To: X3T10 Committee (SCSI)  
From: George Penokie (IBM) and Gene Milligan (Seagate Technology)  
Subject: Comments on SCSI-3 Parallel Interface ammendment rev 00

## X3T10/855A revision 00

# draft proposed amendment to American National Standard Information Technology -SCSI- 3 Parallel Interface

Figure 1 - SCSI-3 document road map

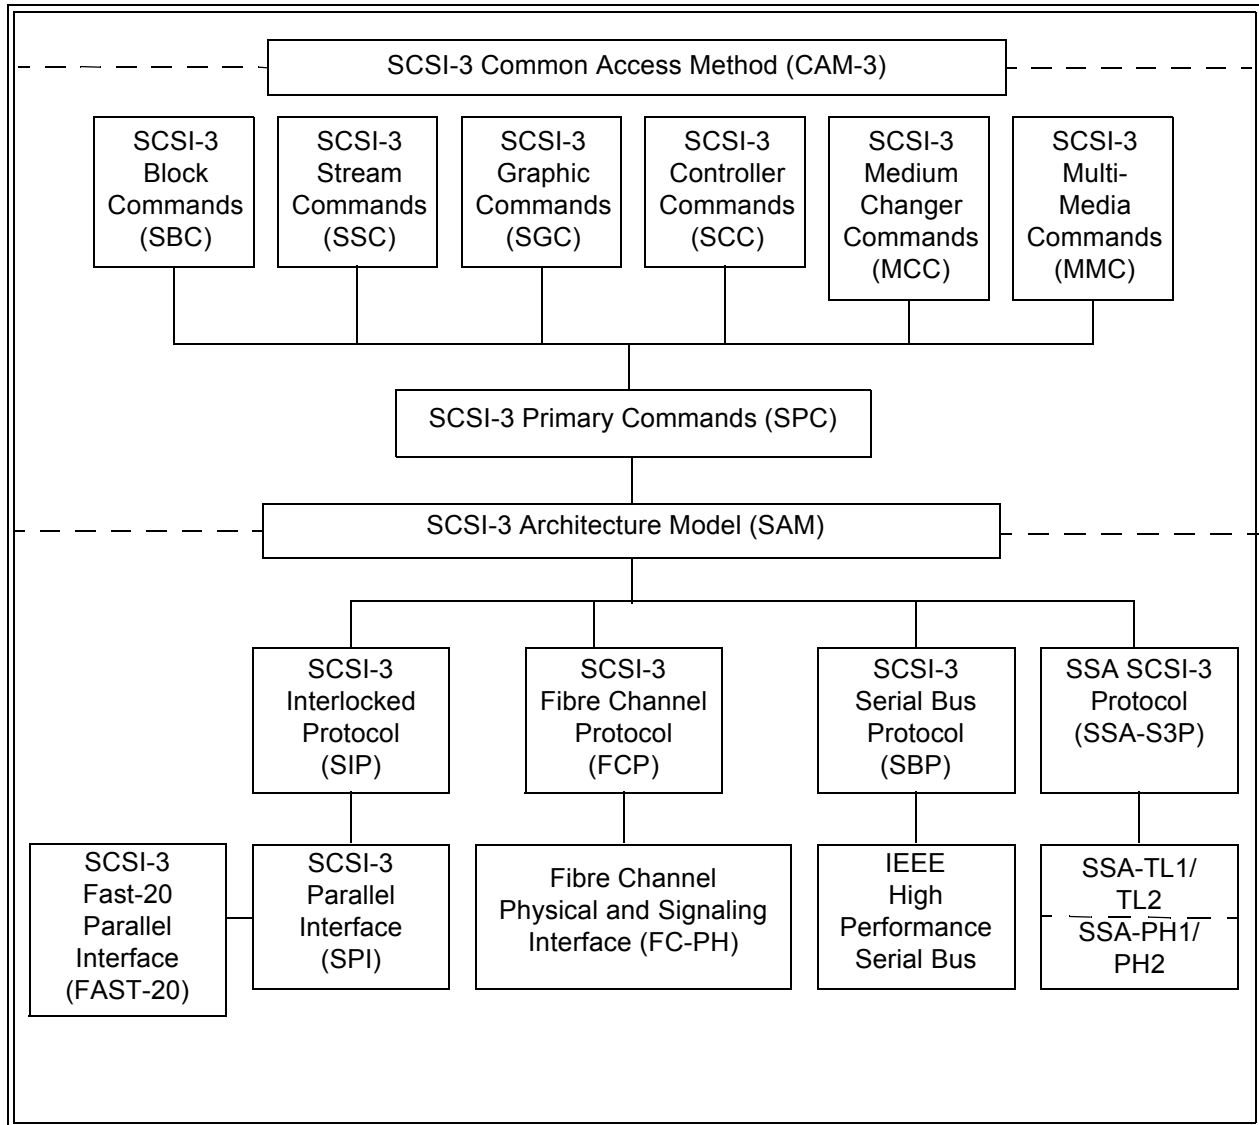
Replace figure 1 with the following:
